To the Zoning Board of Appeals,

The safety of the Peter's Way intersection has been discussed at length. At the 7/25/16 meeting it was suggested that because of fire department concerns about physical barriers, left turns would be prohibited via a "no left turn" sign enforced by the police. However, as the image below indicates, there is no practical place for a police car to park in order to enforce this.

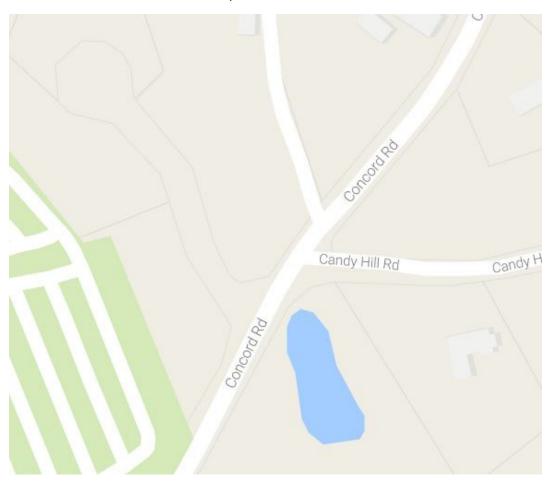
There are two possible locations:

- 1) Base of Candy Hill Road: Parking here would block traffic either entering or leaving Candy Hill Road and is not practical.
- 2) Driveway north of Candy Hill on the west side of Concord Road: This is a narrow driveway serving two homes. Even if both residents did not mind a police car blocking their egress, there is not visibility of Peter's Way from that vantage point because of the queue of vehicles which extends well north of that driveway during rush hour (which is presumably when the police would be attempting to enforce the "no left turn" prohibition).

A common sense analysis indicates that if the police cannot park in a location that provides visual access to the intersection, then the "no left turn" sign is essentially unenforceable and should not be considered a realistic solution to the problem.
